SITING AND GRADING PLAN

Royal Pine Homes / Centerfield Properties Inc - 216102
"OAKRIDGE MEADOWS", RICHMOND HILL, ON

Drawn By: DS Checked By: DS Scale: 1:250 File Number: 216102-SP01.DWG
8966 Woodbine Ave, Markham, ON L3R 0J7 T 905.737.5133 F 905.737.7326
Lot / Page Number: **BLOCK 66**

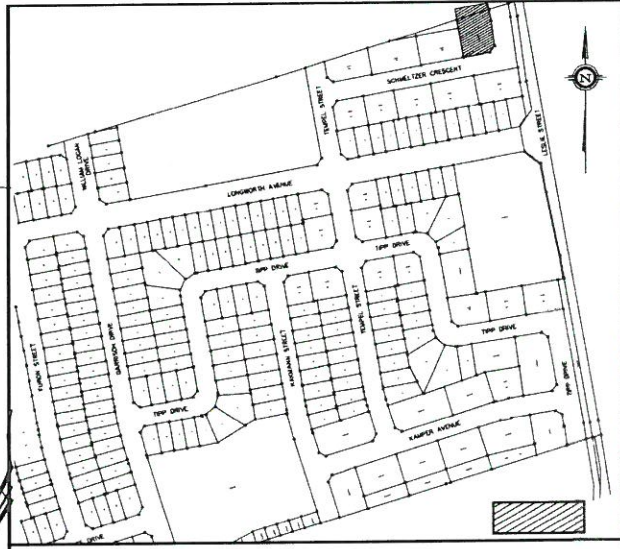
As per OBC 2012, Div.B, 9.10.14.5(5), projections such as balconies, eaves, stairs, etc., that are more than 1m above grade, shall be non-combustible when within 1.2m of a property line or 2.4m of a combustible projection on another building on the same property.
